November 25, 2009  
Subject: Gulf of Maine Research Institute Pier Replacement  
**Amendment No. 1**

Make the following changes to the Bid Documents:

DEWATERING BARRIER

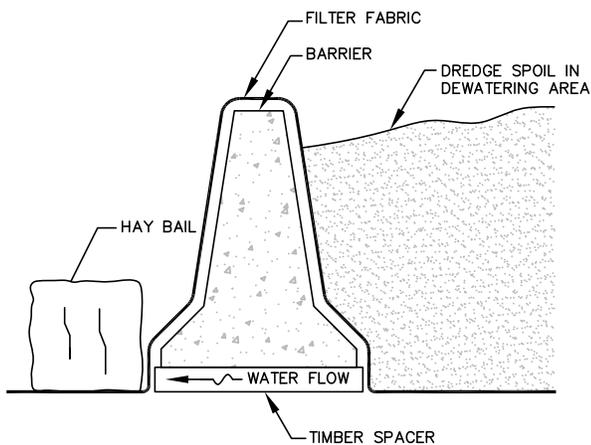
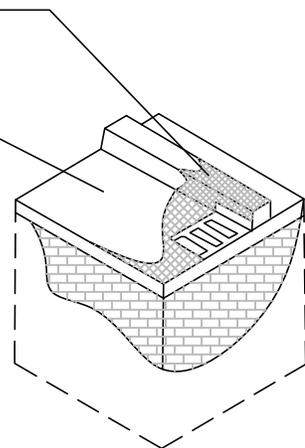
Submit a Dewatering Plan of the dredge spoils. Include layout details, berm construction and proposed berm materials, and operating procedures. Plan must be stamped and signed by a licensed registered Professional Engineer. No dredging activities shall begin until the dewatering plan is approved by the Engineer.

**DEWATERING NOTES:**

1. CONSTRUCTION:
  - a. CONSTRUCTION OF ALL EROSION AND SEDIMENT CONTROL DEVICES, SIGNAGE AND CONSTRUCTION FENCING MUST BE COMPLETED AND APPROVED BEFORE DREDGE SPOILS ARE PLACED AT THE DEWATERING SITE.

2. GENERAL
  - a. THE CONTRACTOR SHALL MANAGE THE PLACEMENT, CONFIGURATION, DEWATERING AND REMOVAL OF THE DREDGE SPOILS SUCH THAT THE DEWATERING SYSTEM REMAINS FULLY FUNCTIONAL FOR THE DURATION OF THE WORK WITH PERIODIC MAINTENANCE. SPECIAL ATTENTION SHALL BE GIVEN TO INCREASING LEVELS OF WATER CAUSED BY RAIN, SNOW, ICE AND ANY OTHER EVENT WHICH CAUSES AN OVERFLOW SITUATION. AN OVERFLOW SITUATION EXISTS WHEN EITHER THE TEMPORARY CONTAINMENT BERM OR THE DEWATERING DRAIN SYSTEM CANNOT RETAIN OR ADEQUATELY REMOVE THE FREE WATER IN / FROM THE DEWATERING SITE. AS APPROVED, CONTRACTOR SHALL STAGE THE MATERIALS, INCREASE BERM LIMITS, OR PROVIDE ADDITIONAL DRAINS AS NEEDED TO PREVENT OVERFLOW, AT NO ADDITIONAL COST TO THE OWNER.

- b. CONTRACTOR SHALL PAY SPECIAL ATTENTION TO DEWATERING DURING FREEZING CONDITIONS AND SHALL PROVIDE THE NECESSARY MEASURES TO ENSURE THAT THE REQUIRED DEWATERING IS COMPLETED WITHIN THE PROJECT TIME LIMITS. ADDITIONAL MEASURES INCLUDE BUT ARE NOT LIMITED TO THE INSTALLATION AND MAINTENANCE OF WICK DRAINS, INSTALLATION OF ADDITIONAL DRAINS, MECHANICAL MIXING, CONSTRUCTION OF WINDROWS, LIMITED GRADING, OR OTHER METHODS, PERFORMED AS NEEDED AT NO ADDITIONAL COST TO THE OWNER

3. MAINTENANCE
  - a. TEMPORARY DRAIN STRUCTURES AND BERM SHALL BE INSPECTED IMMEDIATELY AFTER EACH RAINFALL, AT LEAST ONCE DAILY DURING PROLONGED RAINFALL, AND WEEKLY WHEN NO RAINFALL OCCURS. THEY SHALL BE REPAIRED IF THERE ARE ANY SIGNS OF EROSION. A MAINTENANCE INSPECTION REPORT WILL BE MADE AFTER EACH INSPECTION, AND ALL REQUIRED REPAIRS SHALL BE MADE WITHIN 24 HOURS OF REPORT.

- A. INLET BASKETS SHALL BE INSTALLED PRIOR TO PLACING DREDGE SPOILS AND SHALL REMAIN IN PLACE AND MAINTAINED UNTIL COMPLETE.
- B. FILTER FABRIC SHALL BE PUSHED DOWN AND FORMED TO THE SHAPE OF THE BASKET. THE SHEET OF FABRIC SHALL BE LARGE ENOUGH TO BE SUPPORTED BY THE BASKET FRAME WHEN HOLDING SEDIMENT AND EXTEND AT LEAST 6" PAST THE FRAME. THE INLET GRATE SHALL BE PLACED OVER THE BASKET/FRAME AND WILL SERVE AS THE FABRIC ANCHOR.

- C. THE FILTER FABRIC SHALL BE A GEOTEXTILE FABRIC; POLYESTER, POLYPROPYLENE, STABILIZED NYLON, POLYETHYLENE OR POLYVINYLIDENE CHLORIDE MEETING THE FOLLOWING SPECIFICATIONS: GRAB STRENGTH: 45 LB. MIN. IN ANY PRINCIPAL DIRECTION (ASTM D1682) MULLEN BURST STRENGTH: MIN. 60PSI (ASTM D774)

- D. THE FABRIC SHALL HAVE AN OPENING NO GREATER THAN A NUMBER 20 U.S. STANDARD SIEVE AND A MIN. PERMEABILITY OF 120 GPM/S.F. (MULTIPLY THE PERMITTIVITY IN SEC.-1 FROM ASTM 54491-85 CONSTANT HEAD TEST USING THE CONVERSION FACTOR OF 74.)
